Staff Report & Recommendation

Historic Preservation Board

SUBJECT: HPB16-0068, **1434 Washington Avenue.**

The applicant, Clay Hotel Partnership, LTD c/o Infinity Real Estate, is requesting a Certificate of Appropriateness for the partial demolition, renovation and restoration of all structures on the site and variances to reduce the required rear setback, to relocate a projecting sign and to reduce the minimum size required for hotel units.

2-story courtyard buildings

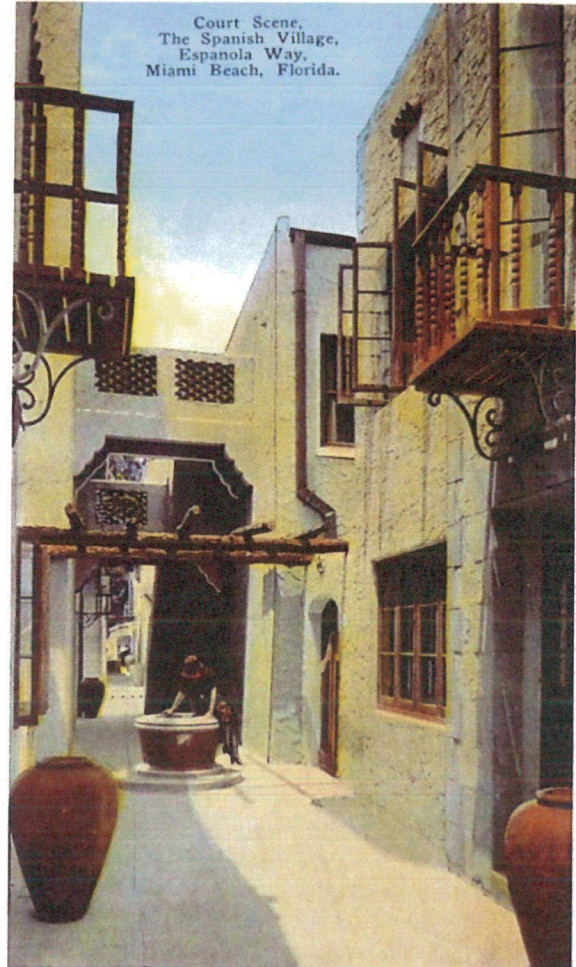
Four 2-story structures are located within the courtyard space formed by the street facing buildings. The structures are paired together so that the entrance to each building is across from the other. Each of the four building entrances features a slightly different frontispiece design. The narrow passageways formed from the remaining courtyard space reinforce the Spanish Village concept. Notably, the special character of the 'Court Scene' of the Spanish Village was the subject of an early colored postcard as shown on the following page. Within the courtyard space, the applicant is proposing a number of alterations.

Staff has no objection to the activation of the roofs in order to add hotel amenities; however, staff is concerned with regard to the impact the pedestrian bridges will have on the defining architectural features of the courtyard buildings (see images on following page). Although complete a complete set of existing, demolition and proposed elevations for the courtyard buildings have not been provided at this time it is clear that portions of all of the projecting entrance features will be required to be demolished in order to introduce the proposed pedestrian bridges at the second and roof levels.

In order to retain and restore the existing projecting courtyard building entrances, staff recommends that the bridges be repositioned to the south of the projecting features.

New FPL vault and boiler room

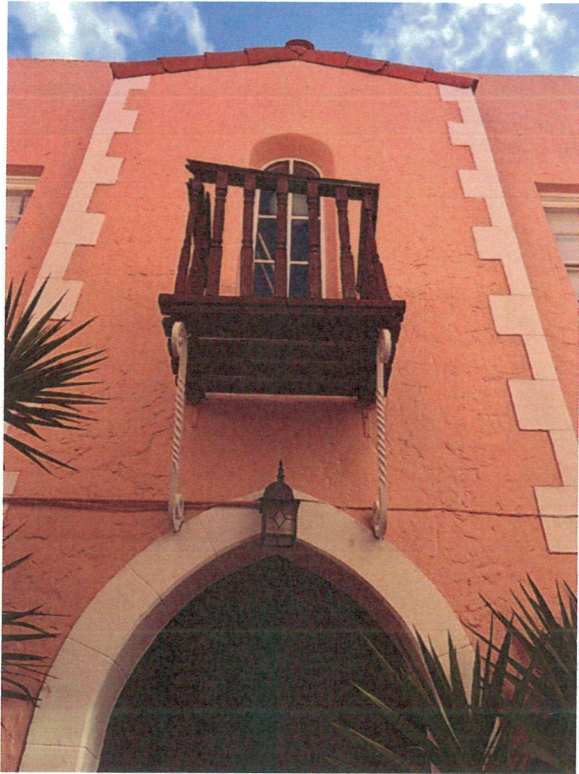
As currently proposed, these structures have been located within the original courtyard. Staff believes that the introduction of this large 2-story mechanical and utility room has an adverse impact on the character of this outdoor space. Notwithstanding the applicant's failure to provide detailed elevations of this structure, staff would recommend that the FPL and boiler room equipment be located within an existing building envelope.
